Title of Change:	Change of backside coating layer material and marking format (pin 1 appearance) for parts with backside coating
Proposed First Ship date:	19 Jul 2022 or earlier if approved by customer
Contact Information:	Contact your local onsemi Sales Office or Marek.Haluska@onsemi.com
PCN Samples Contact:	Contact your local onsemi Sales Office. Sample requests are to be submitted no later than 30 days from the date of first notification, Initial PCN or Final PCN, for this change. Samples delivery timing will be subject to request date, sample quantity and special customer packing/label requirements.
Additional Reliability Data:	Contact your local onsemi Sales Office or Vladislav.Hrachovec@onsemi.com
Type of Notification:	This is a Final Product/Process Change Notification (FPCN) sent to customers. FPCNs are issued 90 days prior to implementation of the change. onsemi will consider this change accepted, unless an inquiry is made in writing within 30 days of delivery of this notice. To do so, contact PCN.Support@onsemi.com

Final Product/Process Change Notification

Document #:FPCN24594X

Current	Proposal
Backside coating layer material	LC2850 25	LC86R25
Marking format of pin 1

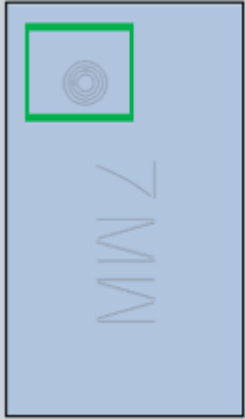
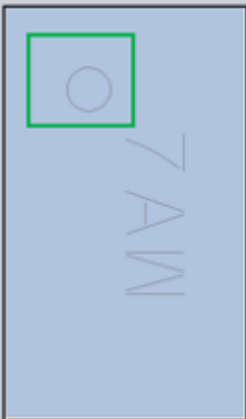
Due to quality improvement process, backside coating layer material and marking format (pin 1 appearance) for parts with backside coating will be changed:
